**RE: Adirondack Rail Trail Construction - Phase 3  
ENB Notice 7/24/2024**

Protect the Adirondacks (PROTECT) has reviewed the proposed Work Plan prepared by the Department of Environmental Conservation ("DEC") for Phase 3 of the Adirondack Rail Trail that was noticed in the July 24, 2024 Environmental Notice Bulletin. Phase 3 involves the extension of the 10-foot-wide Adirondack Rail Trail from Floodwood Road in the Town of Santa Clara to the end of the new parking lot in Tupper Lake. DEC proposes cutting 5,903 trees on Forest Preserve lands as part of the Phase 3 extension, which is 8.1 miles long. The proposed work also involves re-surfacing the existing stone rail-bed with crushed stone and stone dust, and proposes an unspecified number of trail sections that will entail considerable terrain alterations.

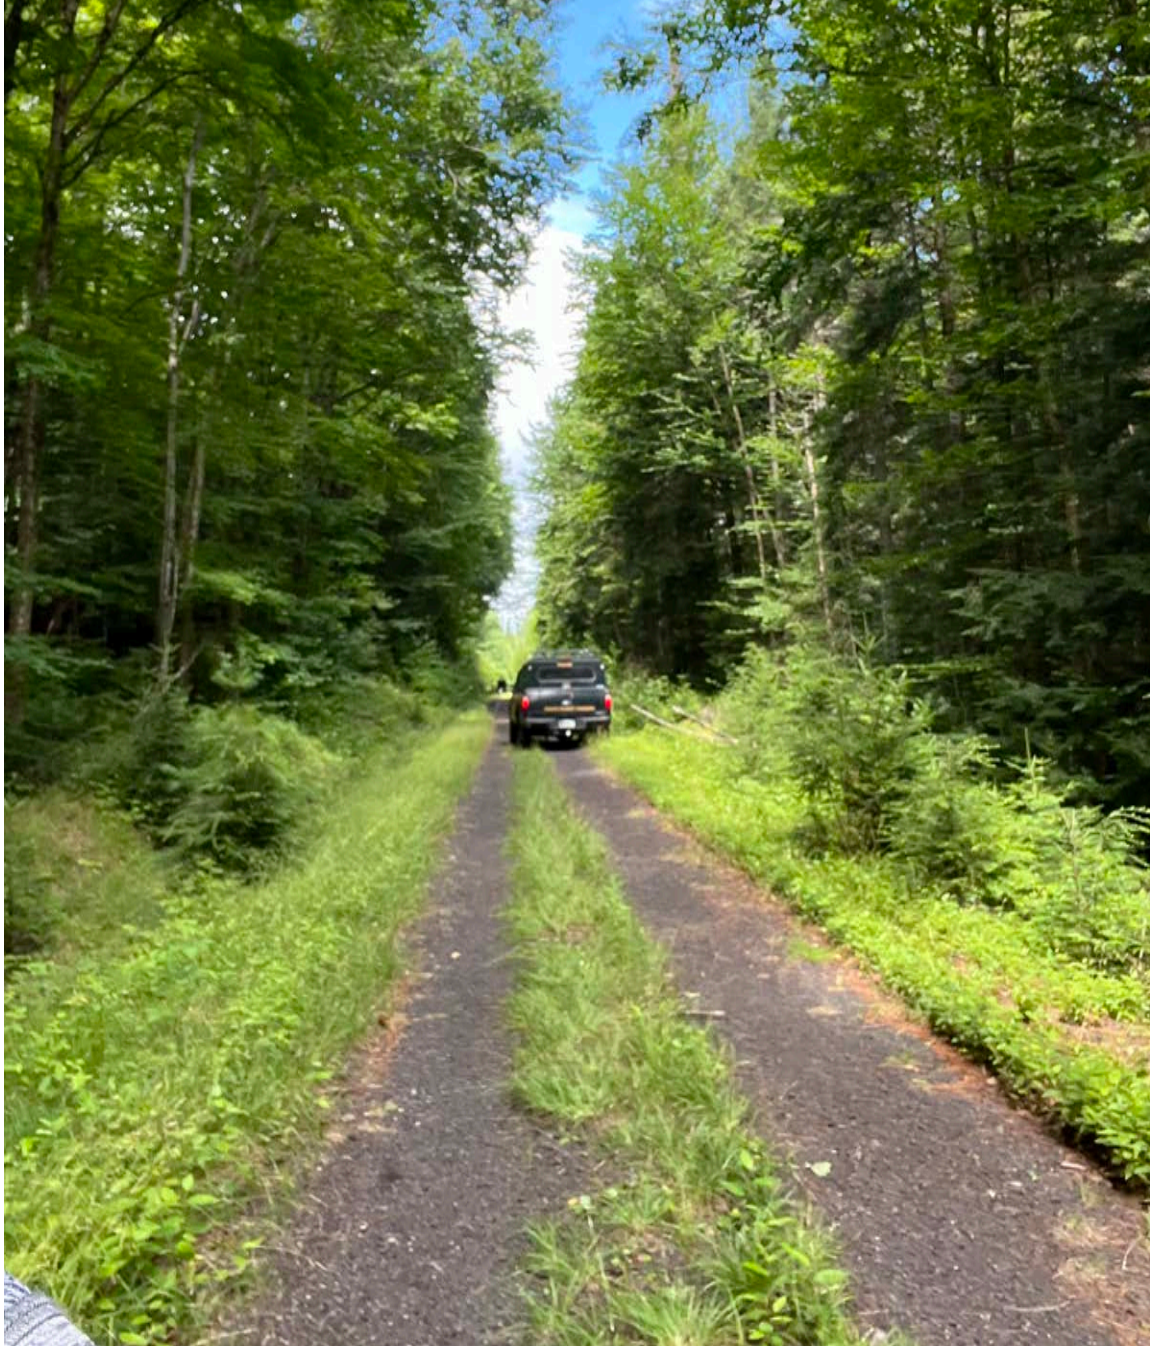
Our field inspection of the Phase 3 corridor revealed that much of the existing railbed already has a flat, treeless surface that is 10 to 20 feet wide, or wider. We have enclosed photographs of the existing railbed for your reference. If the trail is sited through the middle of the existing treeless railbed, then very little tree cutting will be required. CP-78 states that DEC must ensure that the “removal of trees and other vegetation will be minimized to the extent possible” and that DEC must provide “a description and justification for why tree cutting is required.” CP-78 at p. 7. The amount of tree cutting proposed for Phase 3 is arguably an unconstitutional level of cutting. DEC should provide more detail in the Work Plan about the proposed tree cutting, where it is proposed to take place, and the reasons that tree cutting cannot be further reduced, all of which is required to be included in the Work Plan by CP-78. DEC needs to make every effort to reduce the proposed tree cutting on the Forest Preserve to ensure that the Adirondack Rail Trail satisfies the Constitution.

This photograph was taken on Phase 3 of the Adirondack Rail Trail to the west of Rollins Pond. It shows that the existing railbed is approximately 10 feet wide or more and is wide enough for travel by a State pickup truck with clearance on both sides.
